WURLITZER SERVICE SLANTS

SUBJECT:

All Wurlitzer Model 3500 Series Phonographs equipped with Credit Accumulator Relay Box shipped from the factory prior to April 17, 1971.

Figure 1

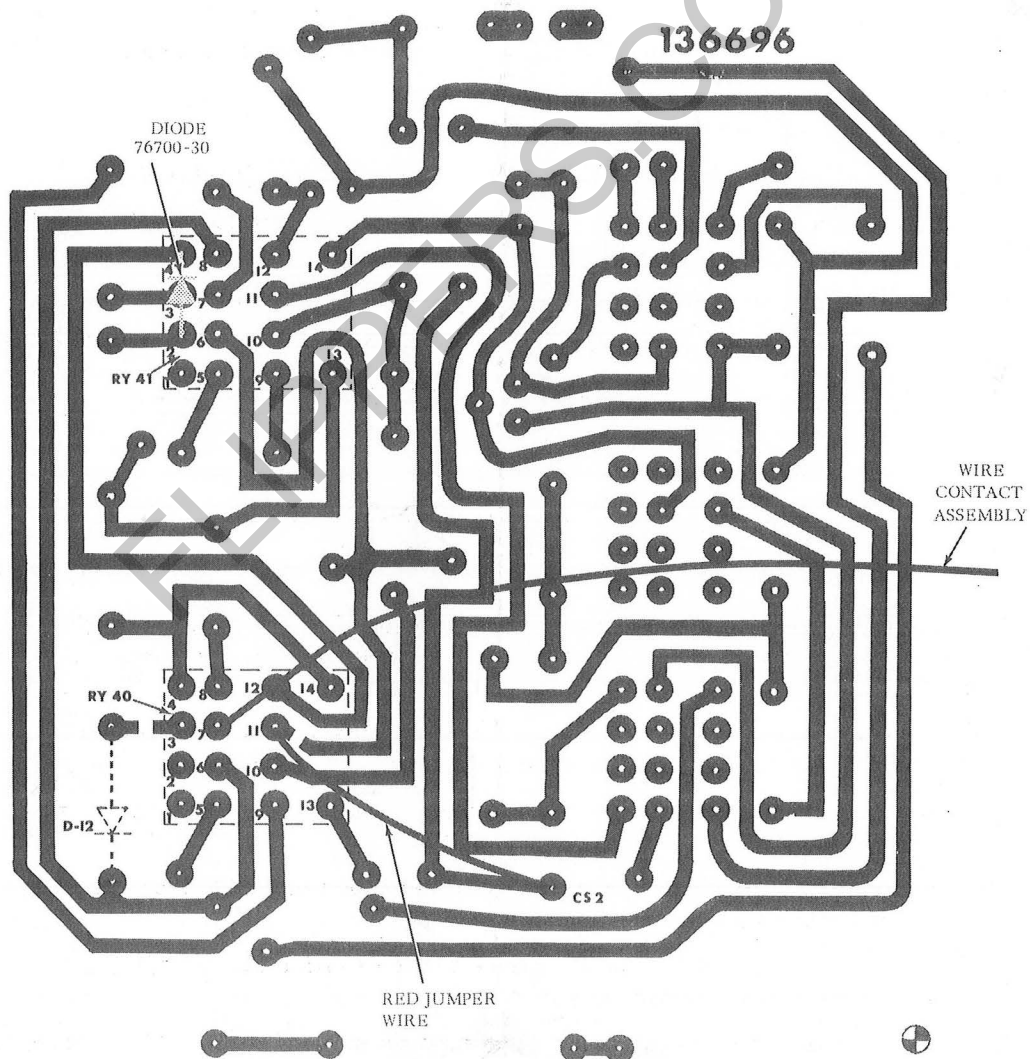
Overcrediting.

6. Using a sharp knife, cut copper trace connecting Pin #3 of RY 40 to anode of Diode D-12; cut copper trace connecting Pin #11 of RY 40 to JB 4 connection. Refer to Figure 1 for location of traces.

8. Cut contact from jumper wire removed in Step 7; strip 1/8 inch of insulation from this wire; tin both ends of wire.
9. Connect and solder red jumper wire tinned in Step 8 between CS 2 connection and Pin #11 of RY 40. See Figure 1 for jumper wire location.

10. Solder Diode, Part Number 76700-30, anode to Pin #2 of RY 41, cathode to Pin #4 of RY 41. See Figure 1 for Diode location.
11. Remove and retain strain relief securing cable with white 15 contact Molex receptacle to Credit Accumulator Relay Box.

13. Feed remaining end of Wire and Contact Assembly through tubing of Credit Accumulator Relay Box cable.
14. Solder tinned end of Wire and Contact Assembly to Pin #7 of RY 40. See Figure 1 for Wire and Contact Assembly location.
15. Reinstall strain relief removed in Step 11.
16. Reinstall Credit Accumulator Relay Box in Phonograph and secure with four screws removed in Step 4.
17. Connect 15 contact and 2 contact receptacles of Credit Accumulator Relay Box cable to respective plugs of Coin Register Mechanism cable.
18. Reinstall cover on upper right hand vertical cable retainer channel.
19. Connect red plug disconnected in Step 1 to COIN MECH. receptacle located on Junction Box.
